Regularisation of the layout of the gas control compound permitted under planning consent TM/04/3135 and installation of a new landfill gas flare at White Ladies Gas Control Compound, Teston Road, Offham, Kent – TM/08/624

A report by Head of Planning Applications Group to Planning Applications Committee on 17 March 2009.

A report by Head of Planning Applications Group to Planning Applications Committee on 9 December 2008.

Proposed Layout Plan

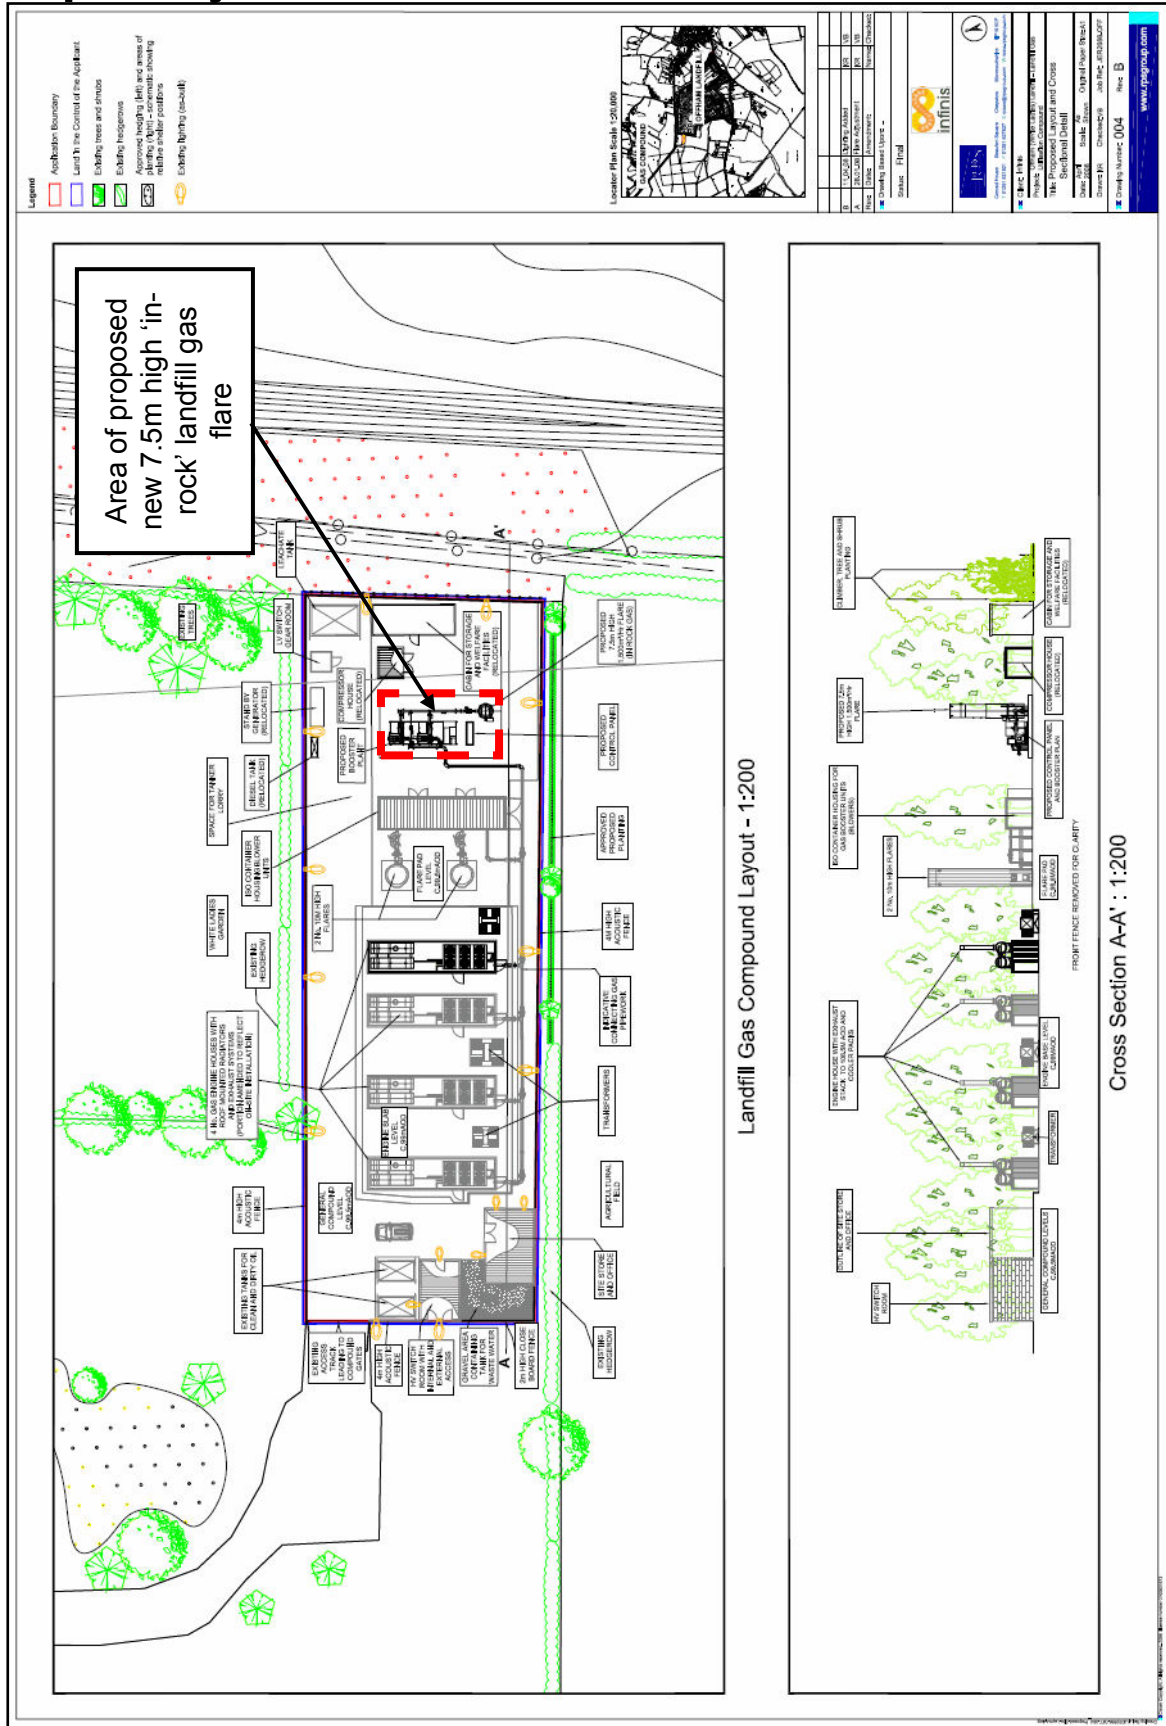
- Although it may prove difficult to alter the location of the specific plant within the compound, the Parish Council has consistently urged that noise producing plant should be located at the furthest point possible from the village boundary;

- It could be argued that one more flare stack, slightly lower than the existing two, will have a marginal impact on the amount of plant already existing. However, marginal as it may be, it will have an impact and a negative one at that in Green Belt terms. The only 'very special circumstances' that would be relevant in relation to this application is stated necessity to comply with EU legislation that landfill gas be controlled and treated;

- The two existing flare stacks at 10m high are visible above the acoustic fencing and planting and therefore have a negative visual impact. The additional flare stack, although lower, is also higher than the 4m high acoustic fencing and planting and will therefore be visible and have an additional negative impact;

- How can the 'predicted noise levels due to the proposed equipment' possibly reduce when two additional pieces of equipment – one flare and one booster – have been added into the equation?
